# **Amendment Report**

# **Application for Licence Amendment**

Licence Number	L8937/2015/1
Licence Holder	Pilbara Ports Authority
File Number	DER2015/002837
Premises	Utah Point Multi-User Bulk Handling Facility
	Portion of Lot 370 on Plan 35619
	PORT HEDLAND, WA 6721
	Certificate of Title Volume LR3118 Folio 753
	As defined by the Premises maps attached to the Revised Licence
Date of Report	20 June 2022
Proposed Decision	Revised licence granted

Figure 1: Proposed SY2 optimisation works (CV04a, CV04b, TS5 and TS6)

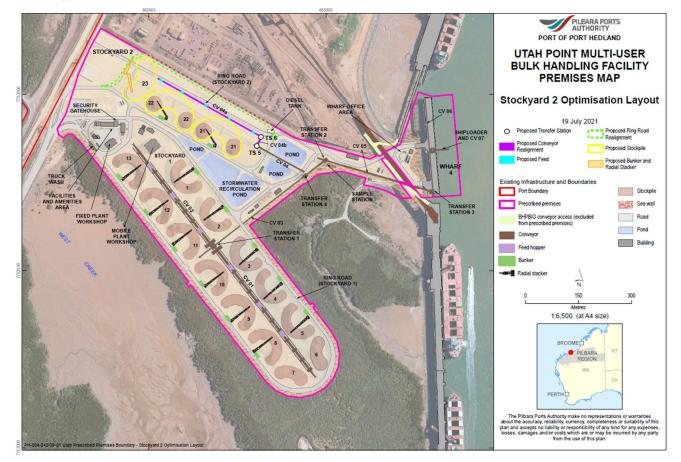
The Licence Holder has identified that the installation of additional outloading feed hoppers at SY2 will reduce the required distance for FELs to travel to and from stockpiles. It is assumed that this will also result in reduced dust emissions from FEL tyre movements. However, increased throughputs will necessitate greater FEL movements overall in order to load more ore onto vessels.

The installation of an additional three feed hoppers at SY2 is expected to decrease the average distance that FELs must travel to load product onto the conveyor system. This reduces the potential for fugitive dust lift off from tyre movement across the stockyard floor.

The Licence Holder has requested flexibility in the type of feed hopper installed as SY2. There are no dust controls (e.g. sprays) for proposed or at existing hoppers, and dust outputs would be effectively the same from either a fixed or mobile hopper. However, there is an opportunity with mobile feed hoppers to optimise the hopper locations with each outloading event. This would require operator intervention which cannot be considered within a dust model.

Due to the confined layout of the current SY2 setup, FELs are required to manipulate stockpiles during stacking to optimise storage capacity. Allowing radial stackers to create larger bean-shaped stockpiles is expected to reduce the need for additional/double handling by FELs during product inload.

#### Figure 6: Premises monitoring locations

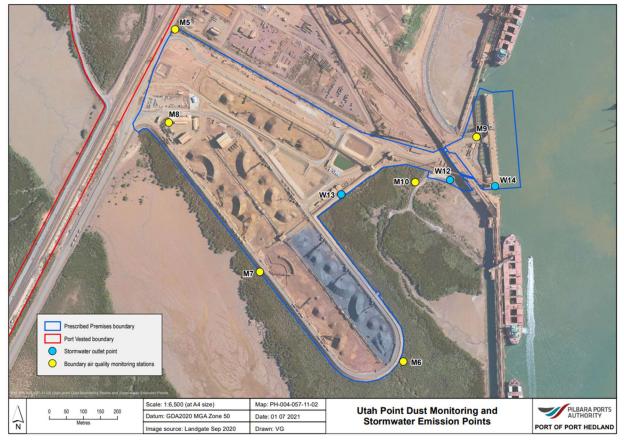
The Licence Holder has proposed improvements to management trigger criteria to address the risk of peak emissions of  $PM_{10}$  resulting in impacts to the health and amenity of Port Hedland receptors. Using a screening model to predict the dispersion profile of  $PM_{10}$ , the Licence Holder has proposed the following changes to trigger criteria:

- a trigger of 392 μg/m<sup>3</sup> for PM<sub>10</sub> (10-minute average) at monitors M5, M6, M7 and/or M10, as depicted in Figure 6;
- reducing the monitoring averaging period for a PM<sub>10</sub> trigger from a 1-hour rolling average to 10-minute average;
- removing consideration of background monitoring data from Yule and BOM monitors and instead calculating Premises attribution by subtracting upwind monitoring data from M5, M6, M7 or M10, depending on wind direction.

a trigger of 342 μg/m<sup>3</sup> for PM<sub>10</sub> (10-minute average) at M10 only, as depicted in Figure 6, and only when winds are within a wind arc of between 247 – 267 degrees as measured at M5<sup>3</sup>;

- reducing the monitoring averaging period for a PM<sub>10</sub> trigger from a 1-hour rolling average to 10-minute average;
- no removal of upwind PM<sub>10</sub> data.

**Key findings:** The Delegated Officer has determined that proposed changes to trigger management are an improvement from those specified on the Existing Licence. While the revised approach appears sound, the proposed criteria differs to that provided on other port

It is noted that proposed triggers attempt to address the risk of very short-term peak dust events and that in some cases, may miss sustained events where dust levels remain high but not extreme.
